Rezoning Transportation Analysis

Petition Number: 2021-079

General Location Identifier: 15705136

Approximate location of Proposed Pedestrian Access

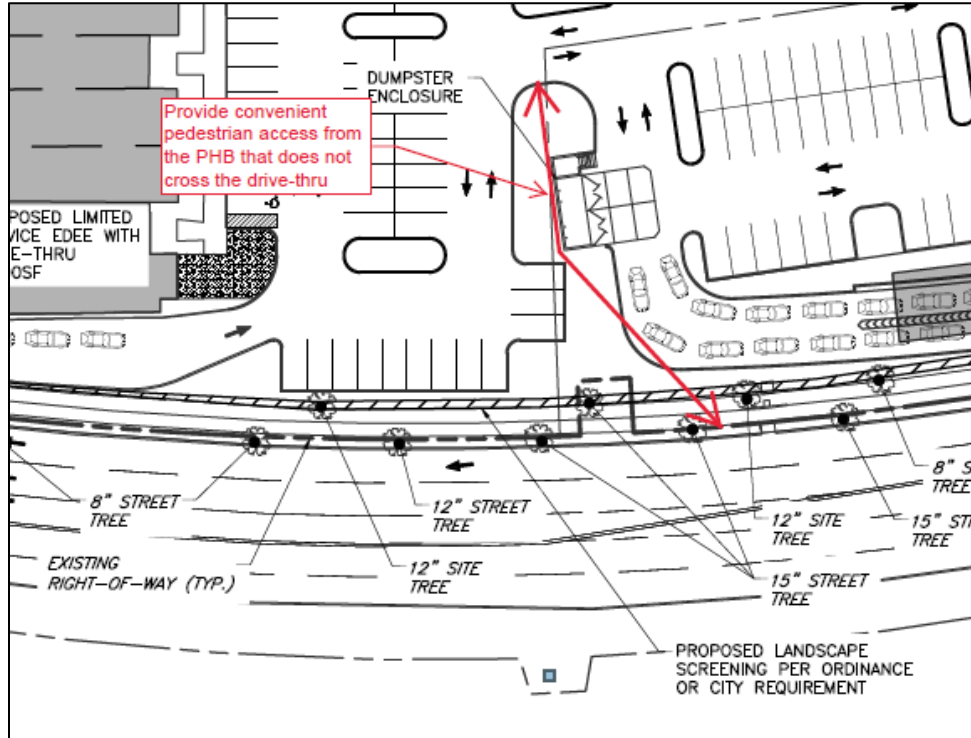
6. ~~Revise site plan and conditional note(s) to commit to provide convenient pedestrian access from the PHB into the site without crossing the drive thru.~~
